**Re: Letter of Notification of PPL Electric Utilities Corporation, Filed Pursuant to 52 Pa. Code Chapter 57 Subchapter G, for Approval to Rebuild Approximately 6.4 Miles of Existing Double-Circuit 138 kV Transmission Line between the Gilbert 138-12 kV Substation and the Little Gap 69 kV Transmission Tap Located in Polk Township and Eldred Township, Monroe County, Pennsylvania
Docket No. A-2018-3001324**

**PPL Electric Utilities Corporation
Response to Data Requests of
Bureau of Technical Utility Services, Set II
Dated May 16, 2018
Docket No. A-2018-3001324**

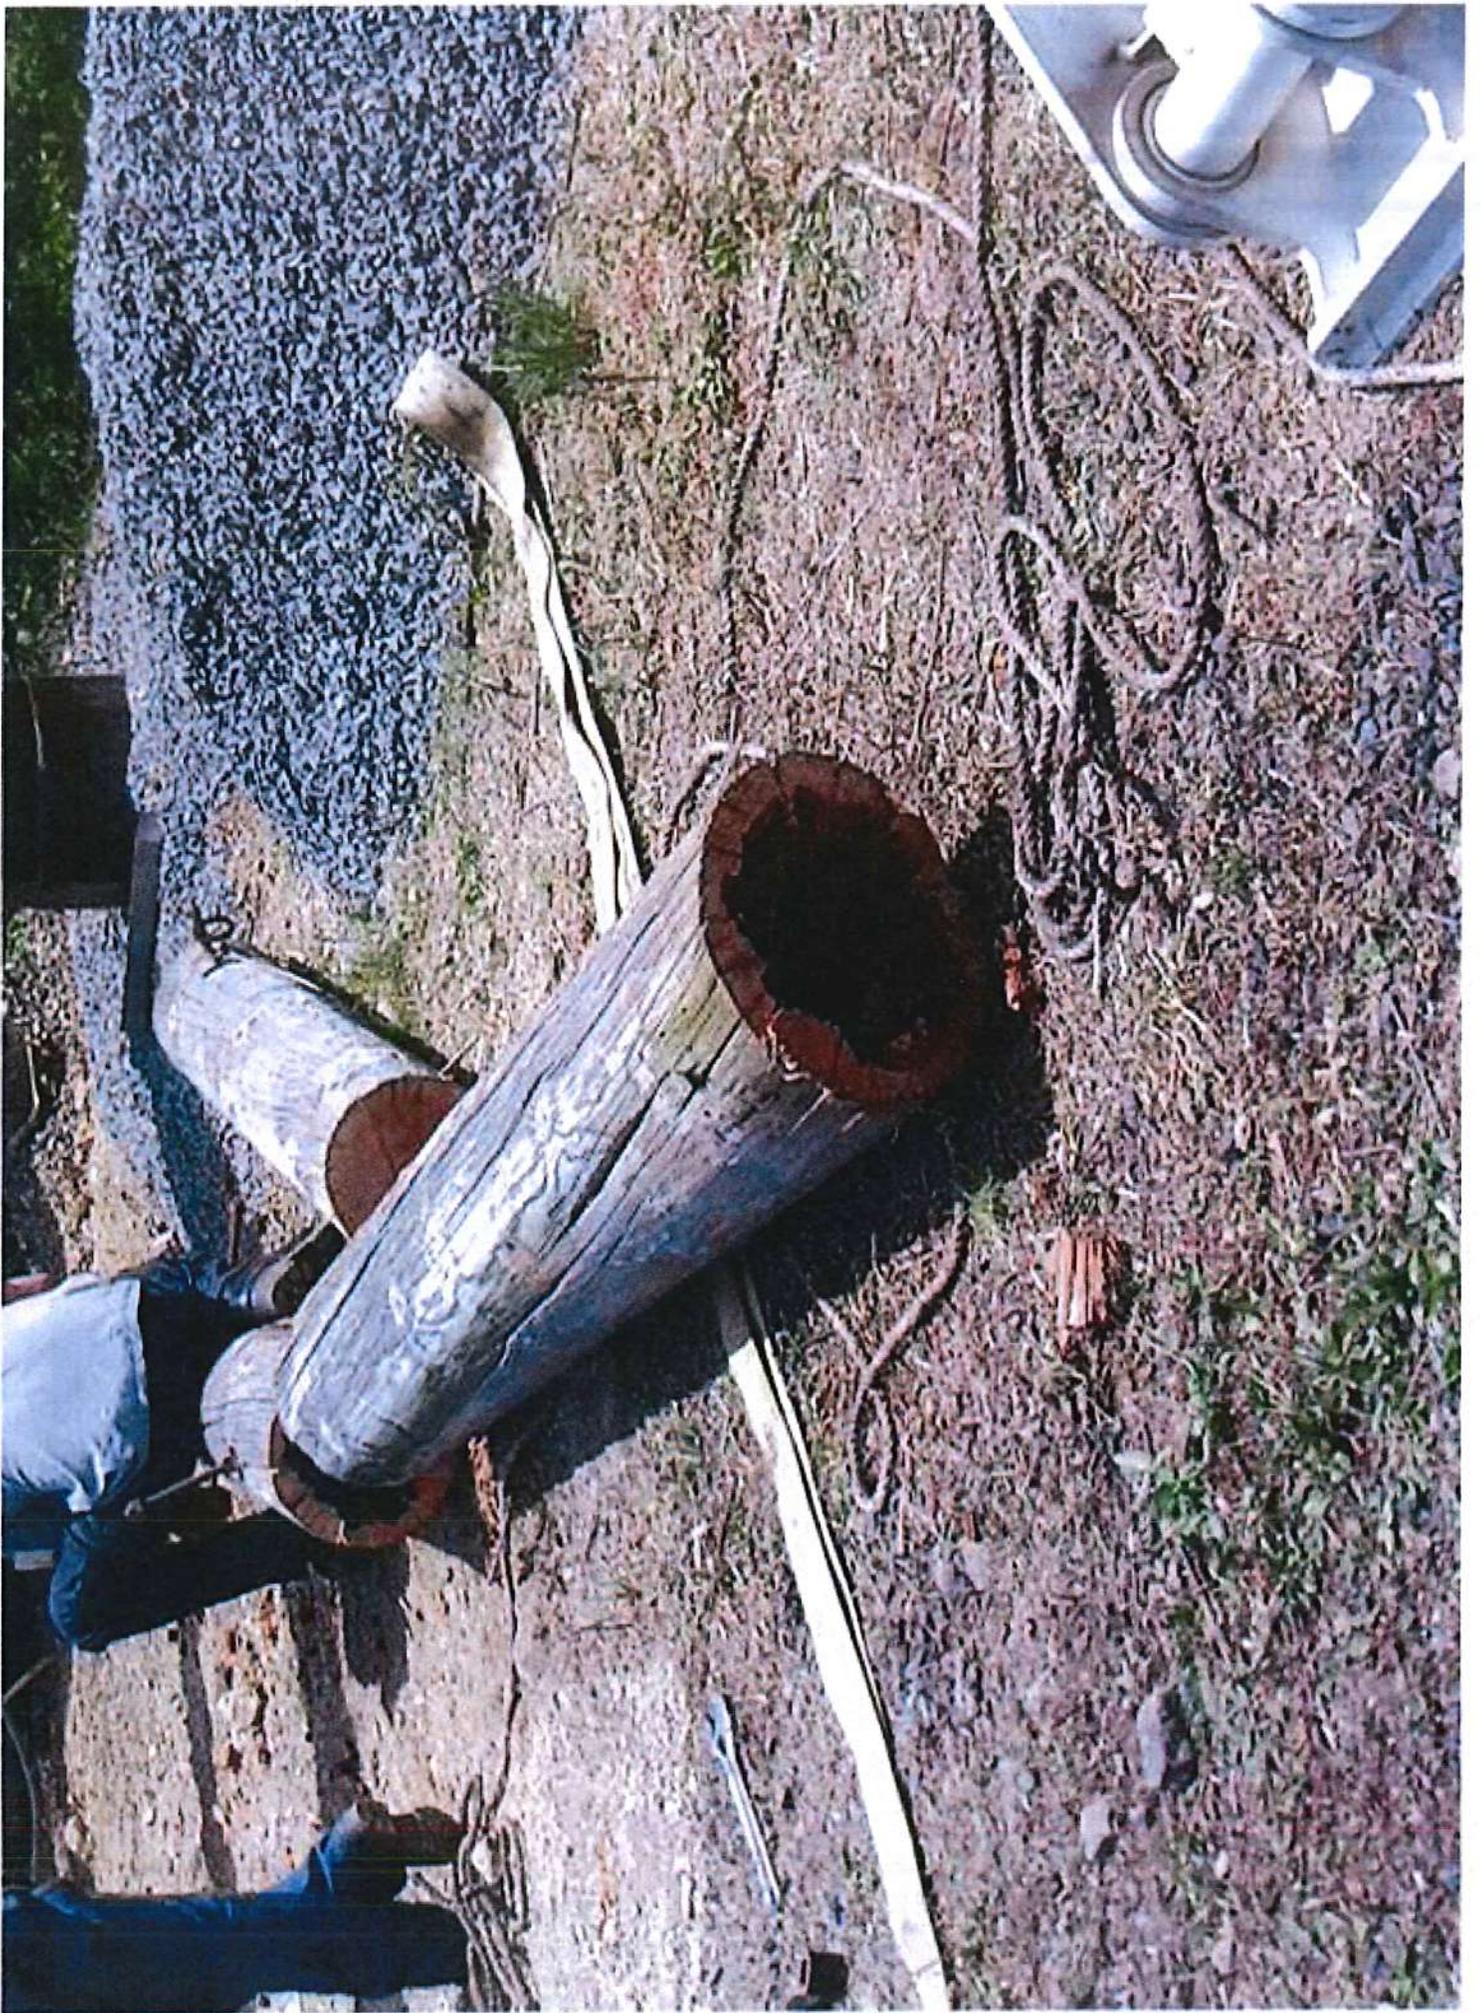
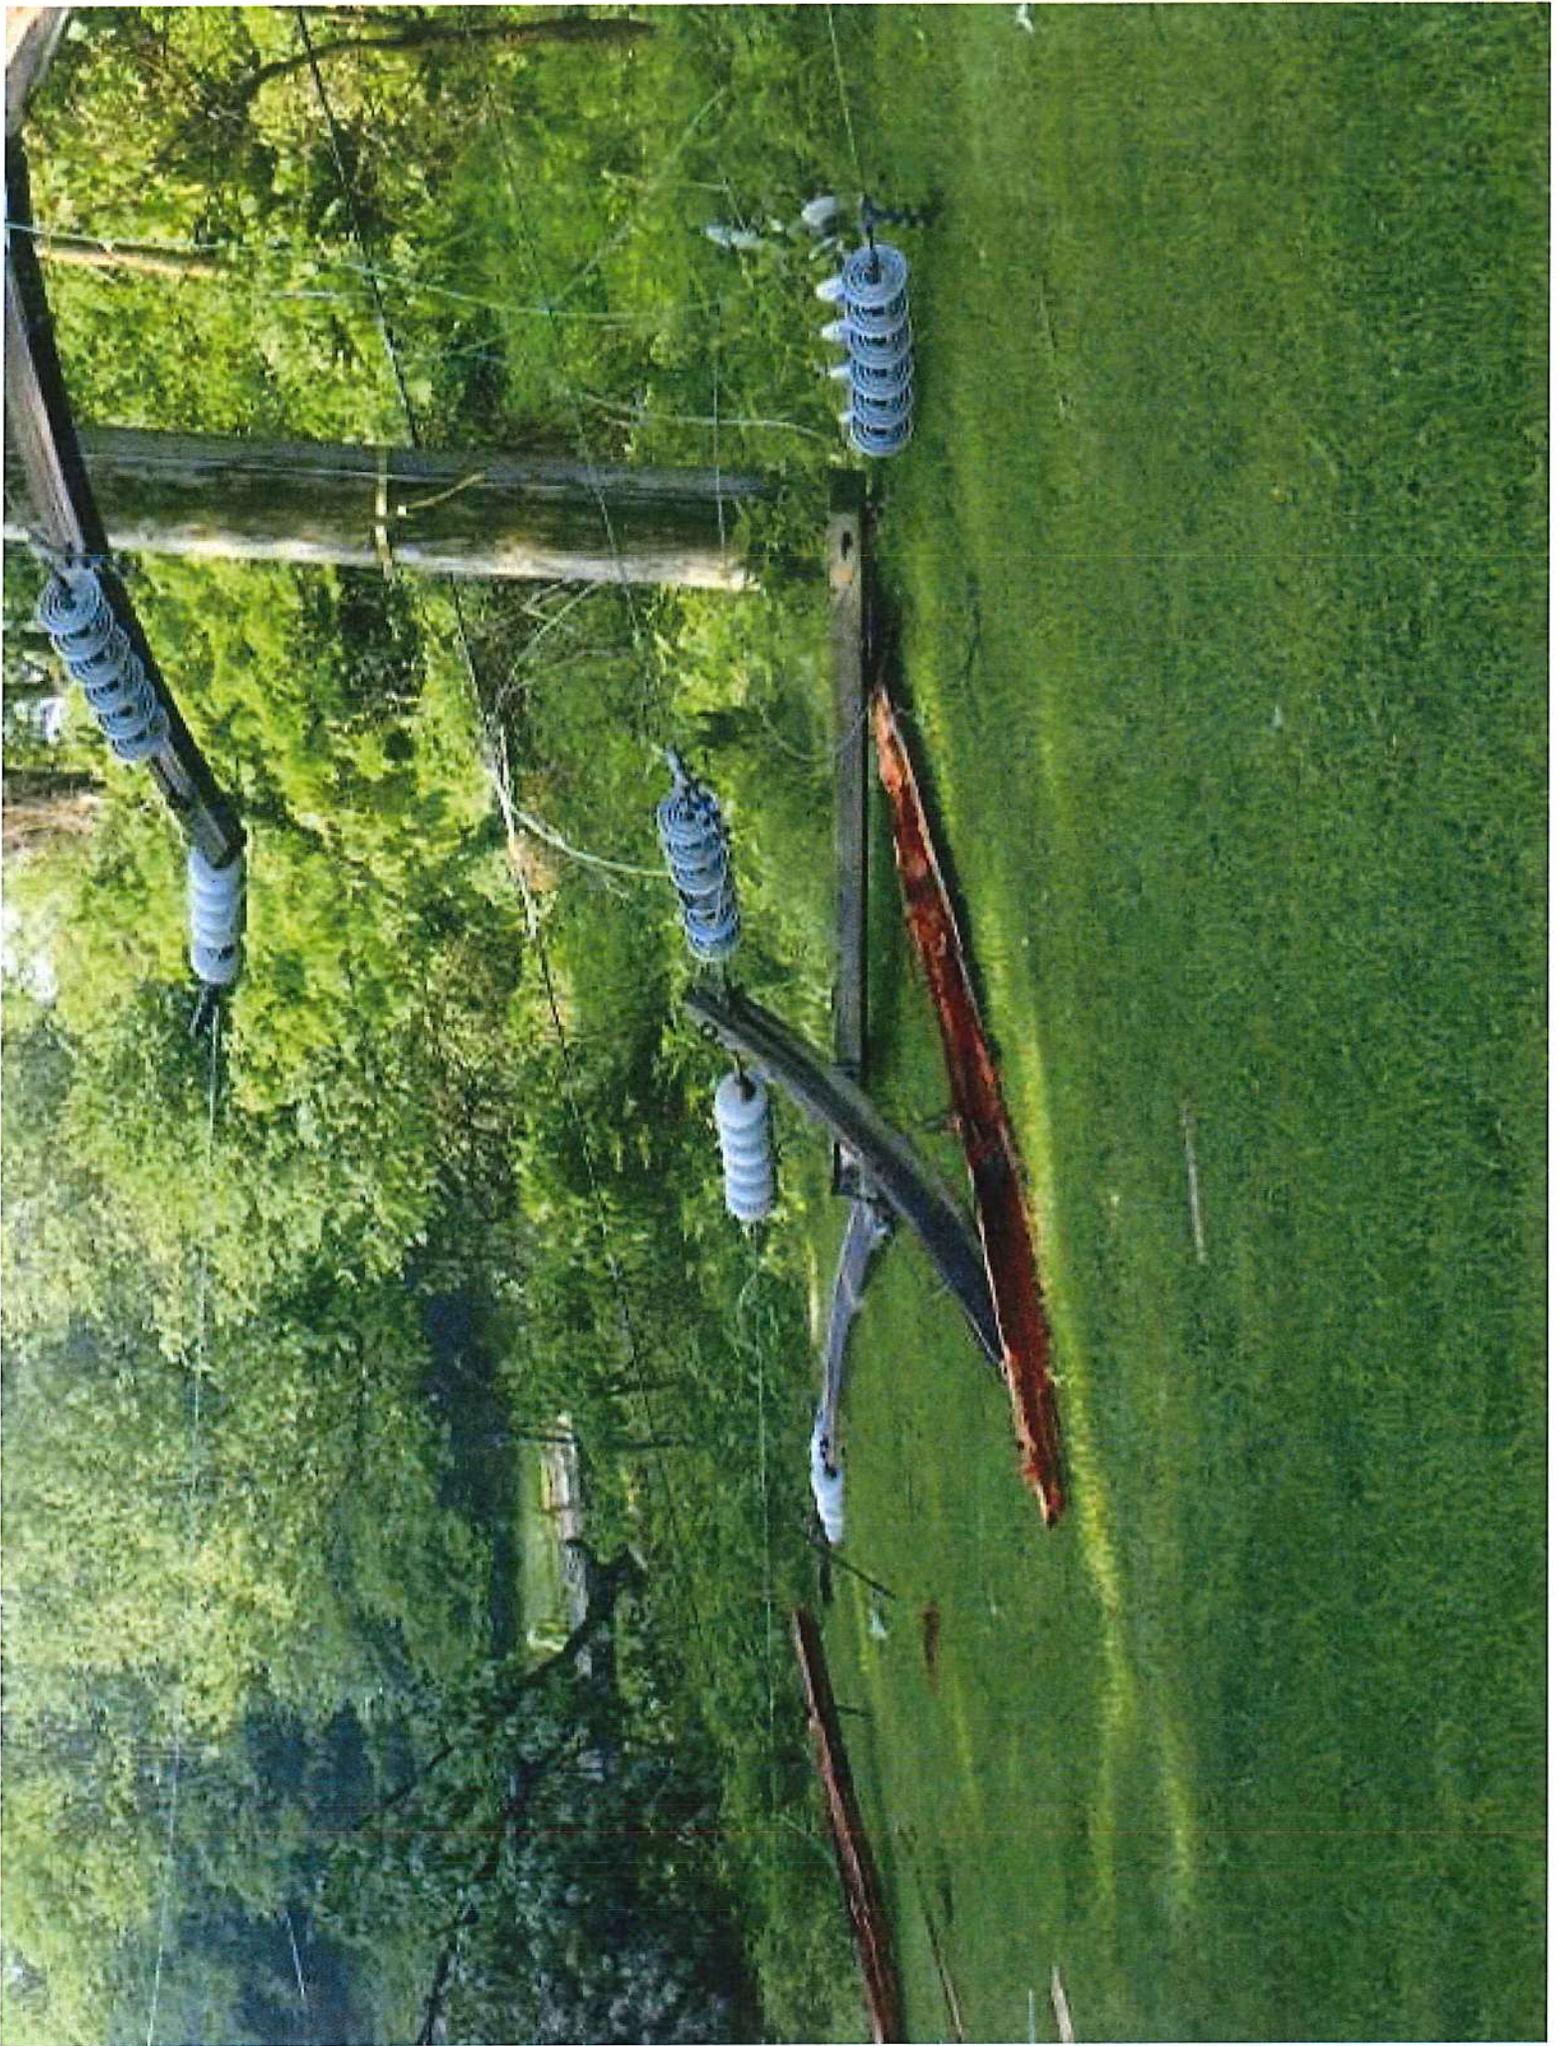
Q.6 Reference Discovery, Response to A-1 and A-2. Please state the structural loading capacity of the existing 8 steel structures and 9 wood poles to be replaced and the approximate structural loading capacity required to accommodate the dual optical ground wire.

A.6 Structural loading capacity of individual structures on a transmission line varies based on a multitude of different parameters, including structure framing, material and span lengths. The engineering of a transmission line involves modelling the structures and the attached conductors/shield wires against an established list of structural loading cases, which subject the structures to different loading conditions based on different types of weather scenarios. For a structure to “pass” it must be below 100% loading capacity and as such it is considered a “fail” if above 100%. Each of the existing structures in question, whether wood or Light Duty (LD) steel poles , are presently loaded to <90% of their design capacity and with the addition of dual optical ground wire (OPGW) attached to newly installed arms they exceeded 100-115% of the loading capacity or “failed”. The majority of the failing structures could not pass the NESC Rule 250B weather case where the structure and each conductor on the ahead and back spans are subjected to weather conditions of 0.5” Radial Ice, 4 PSF Wind, and 0°F Temperature.
